This document replaces the official document ECE/TRANS/WP29/GRE/2021/18; the changes proposed here below in respect to the abovesaid official document and the related additional justification are **highlighted in yellow**.

A. New Supplement to the 06, 07 and 08 series of amendments to UN Regulation No. 48

B. New Supplement [4] to UN Regulation No. 149

Add a new paragraph 2.8. in Annex 12; to read:

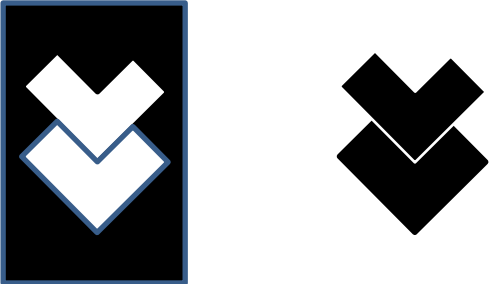
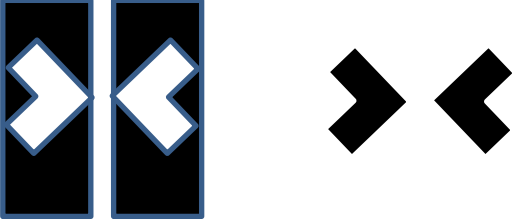
“2.8. For the test sections A, B, C and E in the table above the engineers conducting the tests shall evaluate Driver Assistance Projection if installed.”

4.11. In this paragraph a specification for testing the conformity of Driver Assistance Projection when the ADB tests are carried out has been included.
